**DELAWARE RIVER JOINT TOLL BRIDGE COMMISSION  
EXECUTIVE OFFICES  
2492 RIVER ROAD  
NEW HOPE, PENNSYLVANIA 18938-9519**

**CONTRACT NO. T-668A, CAPITAL PROJECT 0301A  
THE SCUDDER FALLS BRIDGE REPLACEMENT PROJECT**

ADDENDUM NO. 3

**FIGURE 1**

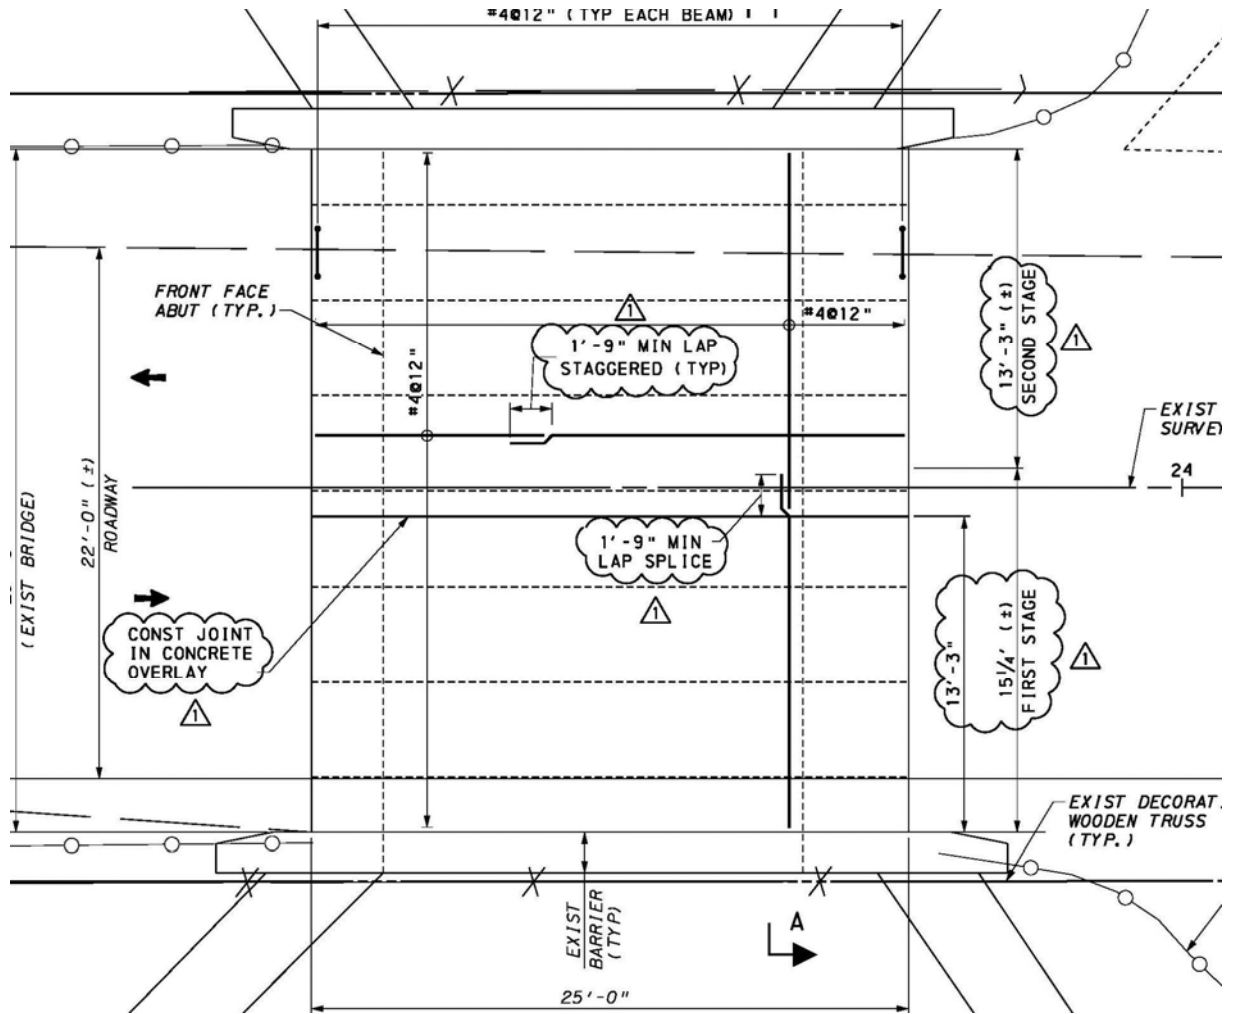
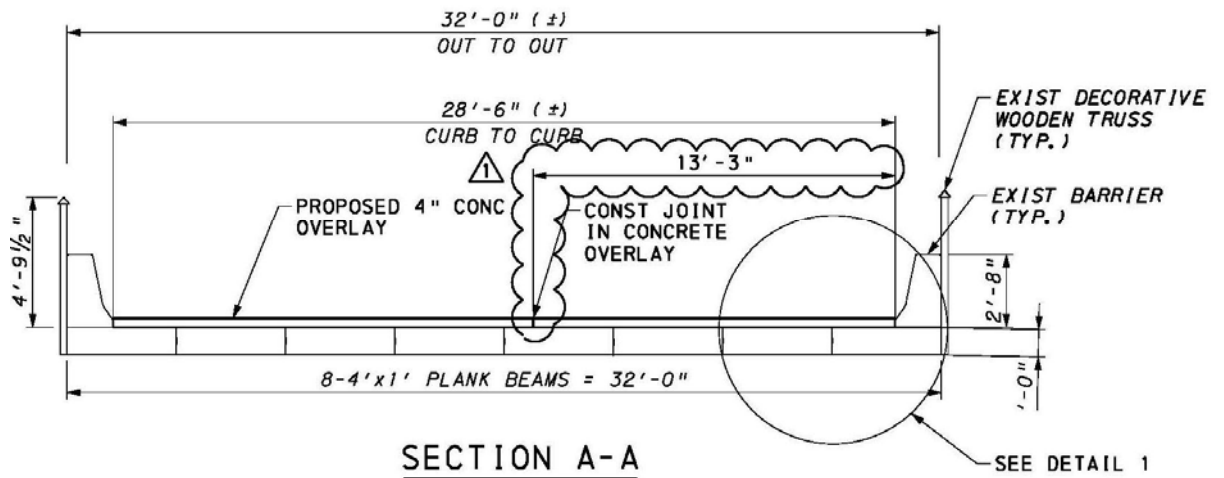
3. On Sheet 55 of 280 in Package A, Part 1, revise “PLAN” and “SECTION A-A” to include additional dimensions as shown “clouded” in Figure 1 and Figure 2 below:
